UNITED STATES PATENT AND TRADEMARK OFFICE

| APPLICATION NO. | FILING DATE | FIRST NAMED INVENTOR | ATTORNEY DOCKET NO. | CONFIRMATION NO. |
|-----------------|-------------|----------------------|---------------------|------------------|
| 09/891,701 | 06/26/2001 | Yuichi Takamine | 36856.516 | 1765 |

Office Action Summary

DETAILED ACTION

FLOWCHARTS FOR 35 U.S.C. § 102(e) DATES:

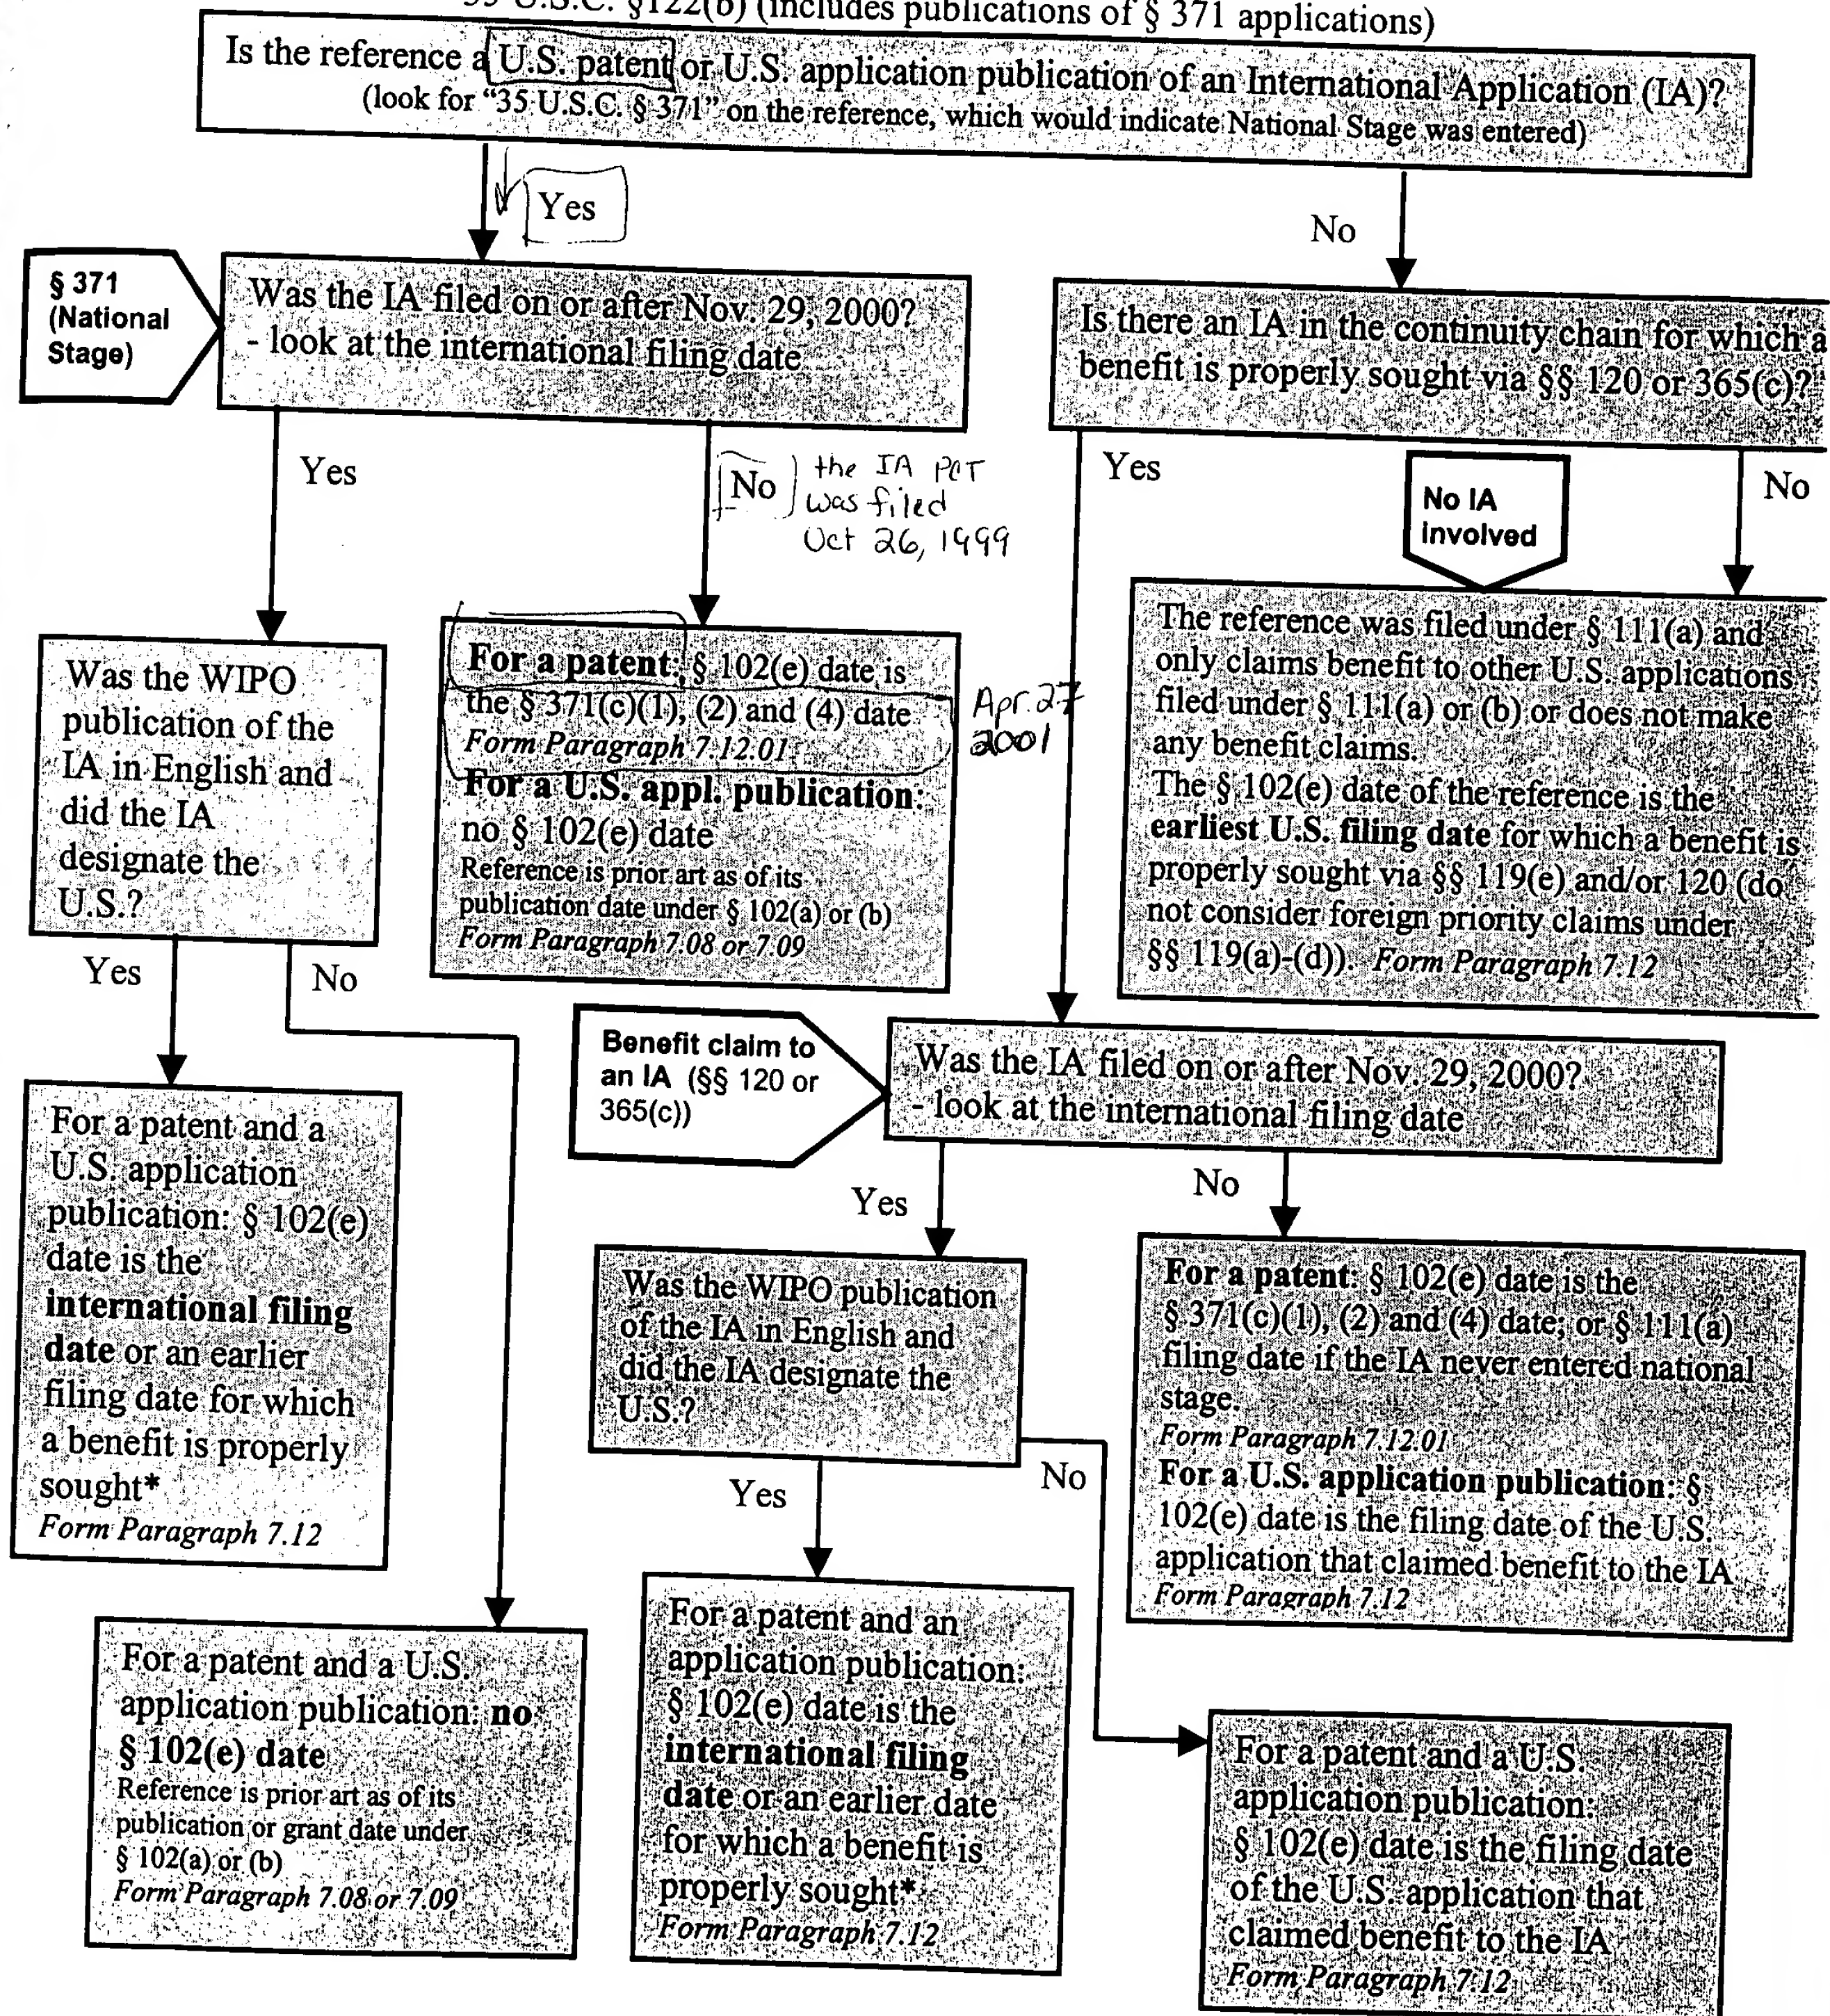
4. Regarding Applicant's belief that the Examiner's rejection under 35 U.S.C. § 102(e) was improper, the Examiner believes the rejection to be proper as can be seen in the attached flow chart provided as part of the latest MPEP revisions [see MPEP § 706.02(f)(1) revised Feb. 2003].

Because the international application (IA) of the Bauer et al. U.S. Patent was not filed on or after Nov. 29, 2000, the § 371(c)(1), (2) and (4) date of April 27, 2001 is the § 102(e) date, and 4/27/01 is approximately two months prior to Applicant's filing date.
